# **BUILDING CODE OF AUSTRALIA 2022 CAPABILITY REPORT FOR DA SUBMISSION**

<b>CLIENT:</b>	<b>NSW HOUSING CORPORATION PTY LTD</b>
<b>PROJECT NAME:</b>	<b>MIXED USE DEVELOPMENT</b>
<b>PROJECT ADDRESS:</b>	<b>2-4 BURLEIGH STREET &amp; 20-24 RAILWAY PARADE, BURWOOD NSW 2134</b>
<b>DATE:</b>	<b>30 JANUARY 2025</b>
<b>PROJECT NO:</b>	<b>230266</b>

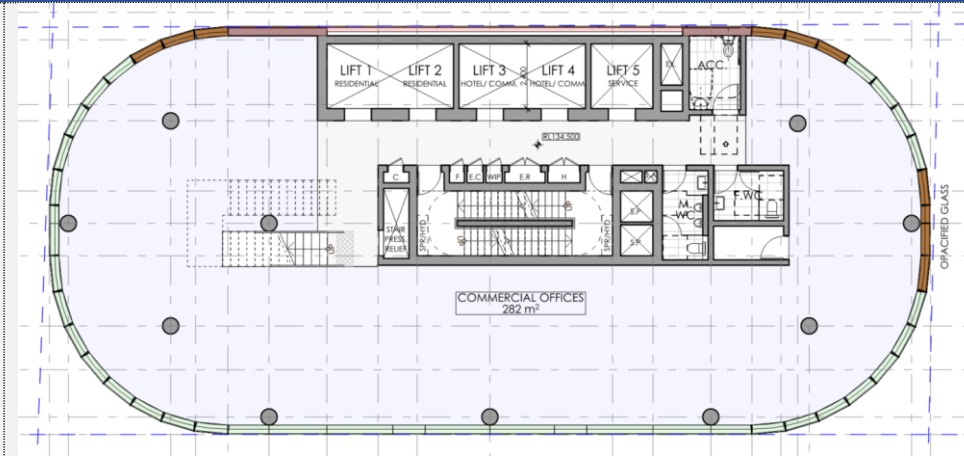
<p>5.</p>	<p>D2D9</p>	<p>The doorway entry into the Hotel Gymnasium on level 2 has a door width of less than 850mm (800mm).</p> 	<p>All doors along the accessway are recommended to achieve a min 850mm clearance as per AS1428.1-2009.</p>
<p>6.</p>	<p>D2D15</p>	<p>Appropriate barriers such as additional bollards are required to prevent vehicles from obstructing the exit in front of the exit adjoining the driveway to the loading/service bay.</p> 	<p>It is in the opinion of this office that compliance with the requirements of this clause can be achieved. A redesign will be required to ensure that appropriate barriers are provided to prevent the exits from being blocked.</p>
<p>7.</p>	<p>E1D2</p>	<p>The coverage of fire hydrants on the Ground level needs to be reassessed and confirmed. Additional fire hydrants will be required to serve the remainder of the storey.</p>	<p>In the event that additional on-floor fire hydrants are provided, a performance solution will be required.</p>

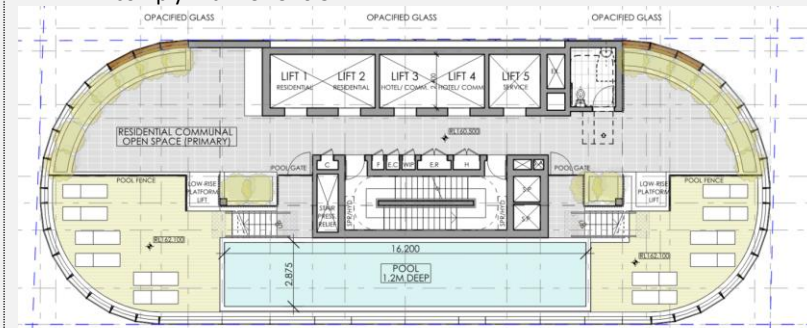
<p>10.</p>	<p>E3D5</p>	<p>The plans identify lifts 1-5 serve all levels of the building. In this regard, at least 2 of the 5 lifts are required to be emergency lifts. Each of the emergency lifts must be in its own fire-resisting shaft. Each emergency lifts must also have a rating of at least 900kg and be provided with a stretcher facility.</p>	<p>The architect is to confirm compliance with the requirements of this clause.</p> <p>It is in the opinion of this office that compliance with the requirements of this clause can be achieved.</p>
<p>11.</p>	<p>F4D4</p>	<p>An additional male urinal is required within the sanitary facilities on commercial levels 33-35. This is based on sanitary facilities serving approximately 29 persons (based on D2D18 calculation of 282m2).</p>	<p>The client / end user to confirm number of persons or fit out of space and a reassessment is to be provided.</p> <p>It is in the opinion of this office that compliance with the requirements of this clause can be achieved.</p>

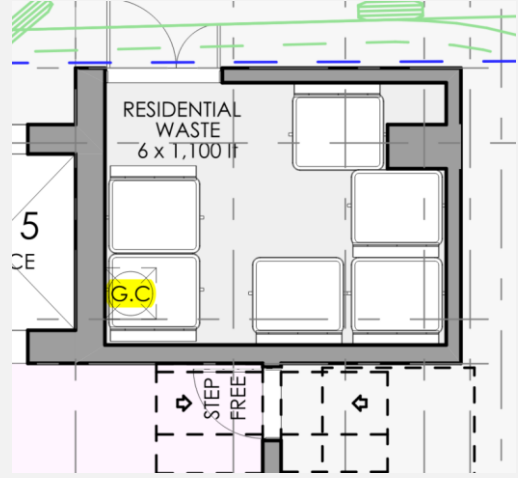
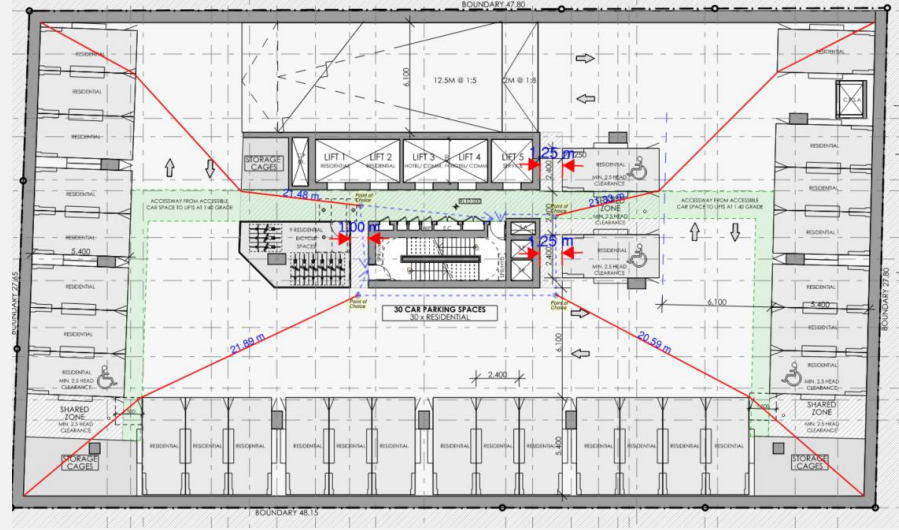
12.

G1D2

The architect is to confirm compliance with the requirements of this clause.

It is in the opinion of this office that compliance with the requirements of this clause can be achieved.

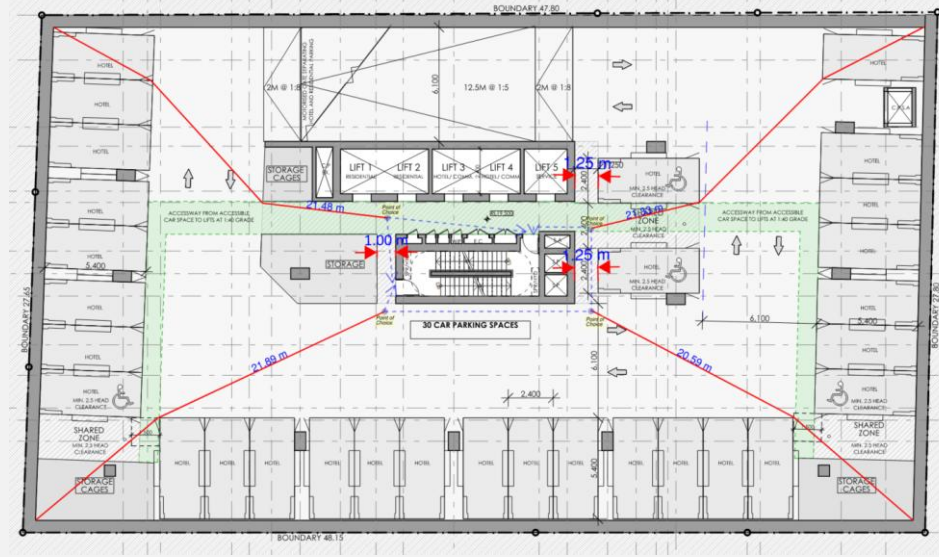
<p>3.</p>	<p>Specification 5</p>	<p>A performance solution will be required to permit the garbage chute shaft to remain unenclosed at the base and be included as part of the same fire compartment as the Ground Floor Garbage Room.</p> 	<p>A performance solution is to be provided at the Construction Certificate Stage.</p>
<p>4.</p>	<p>D2D5</p>	<p><u>Basement Levels 4-5:</u> The travel distance to the point of choice exceeds 20m for each corner of the basement. A performance solution is required to address this non-compliance.</p> 	<p>A performance solution is to be provided at the Construction Certificate Stage.</p>

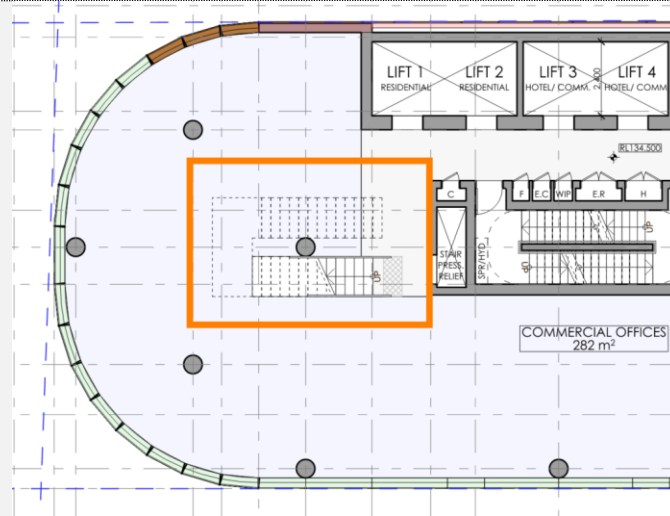
7.	D2D5	<p><u>Extended Travel Distances (Class 2 Portion):</u> The travel distance to the nearest exit is measured more than 6m (up to 7.2m) from the secondary dual key SOU door.</p> <p><u>Extended Travel Distances (Class 3 Portion):</u> The travel distance to the nearest exit is measured more than 6m (up to 9.8m) from the secondary dual key SOU door.</p>	A performance solution is to be provided at the Construction Certificate Stage.
----	------	---	---

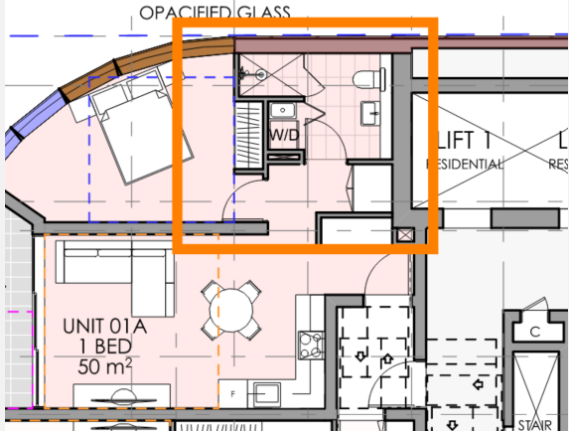
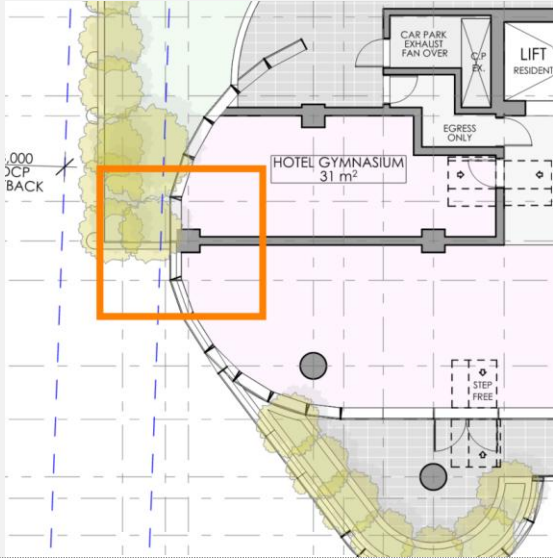
10.	D3D13	<p>To permit service penetrations (rainwater outlets etc) through the Ground Floor slab of the building that is deemed roof as open space to be located within 3m of the path of travel from the egress discharge locations.</p> <p>Note: This clause prohibits all openings within 3m of the path of travel on roof as open space, regardless of whether these openings are protected to achieve the required FRL, as is the case in the subject building.</p>	A performance solution is to be provided at the Construction Certificate Stage.
